CWDM Wavelength Spacing

Proposal for clarification of the 200GBASE-FR4 wavelength spacing budget

IEEE 802.3bs task force

200GBase-FR4 Wavelengths

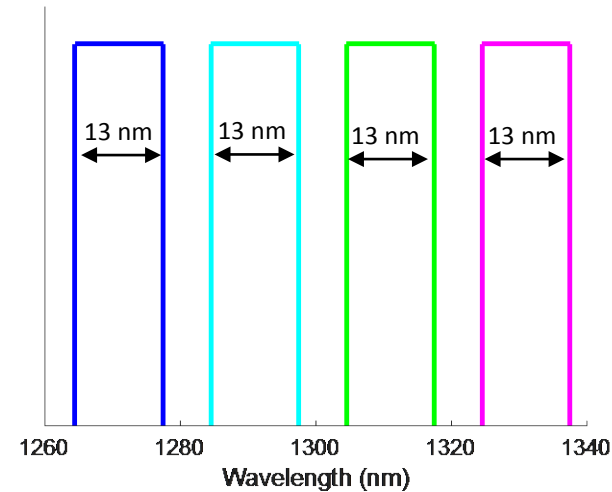
- IEEE 802.3bs in Table 122-5 follows the CWDM wavelength grid defined in ITU-T G.694.2 and allows 13 nm wavelength variation within each channel. Nothing is said in 802.3bs about the characteristics of this variation, leading the reader to assume that all of 13 nm is random variation.

- In all likelihood the lasers of the four channels are co-located on the module. Therefore, any temperature changes will cause a wavelength shift in same direction and by roughly the same amount for all four channels. This type of variation is less challenging to design for, compared to the random.

- Therefore, it would be useful to specify what portion of the 13 nm is due to manufacturing variation of the laser wavelength and what portion the variation can be expected to be similar for all of the four lasers.

Demux Improvement – Cross Talk and Insertion Loss (e.g., MZI-Based Demux)

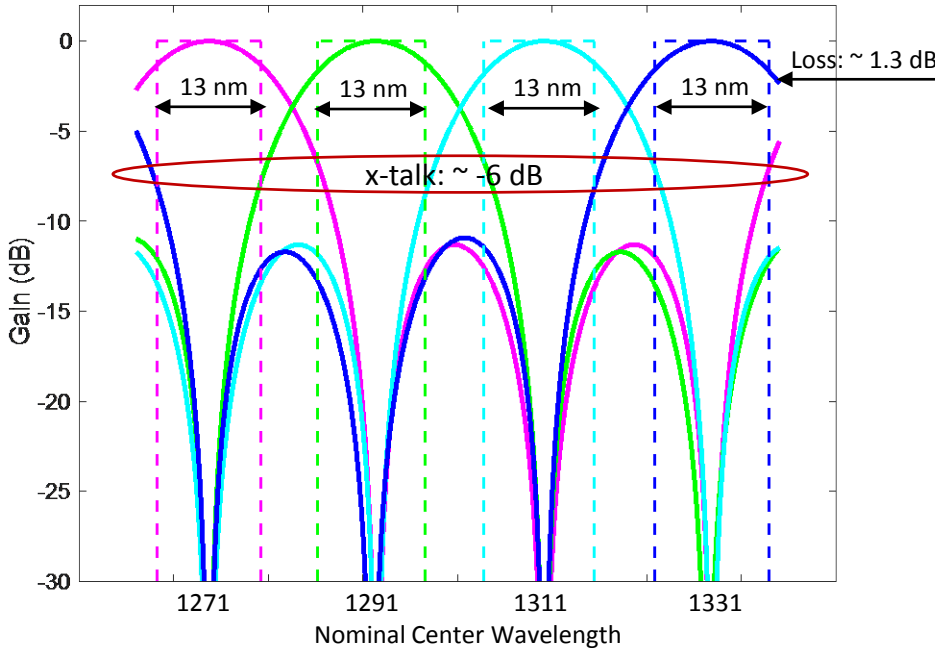
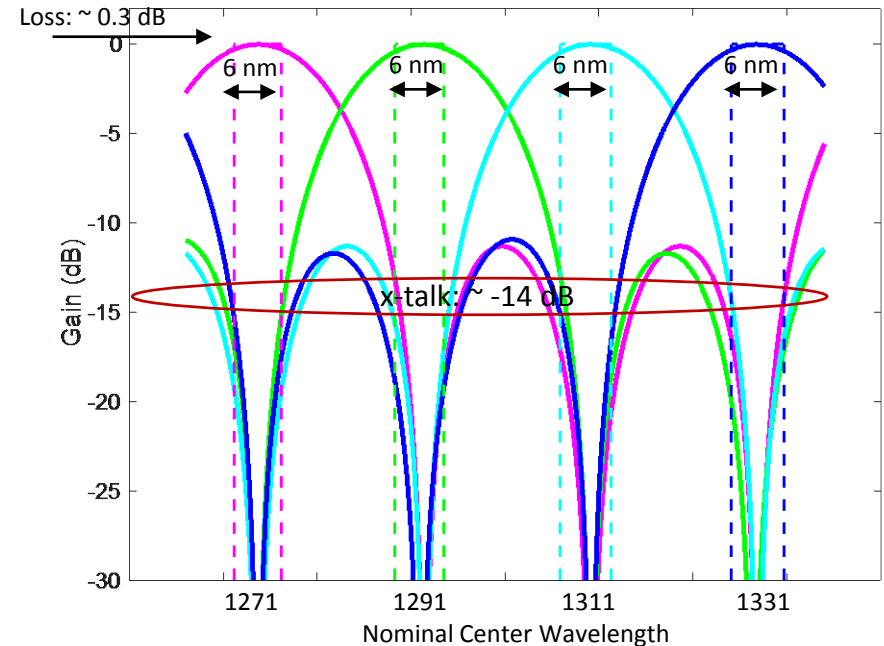
WL Variation	x-talk (dB)	Loss (dB)
13 nm	-6	1.3
6 nm	-14	0.3

13 nm random wavelength variation

6 nm random wavelength variation
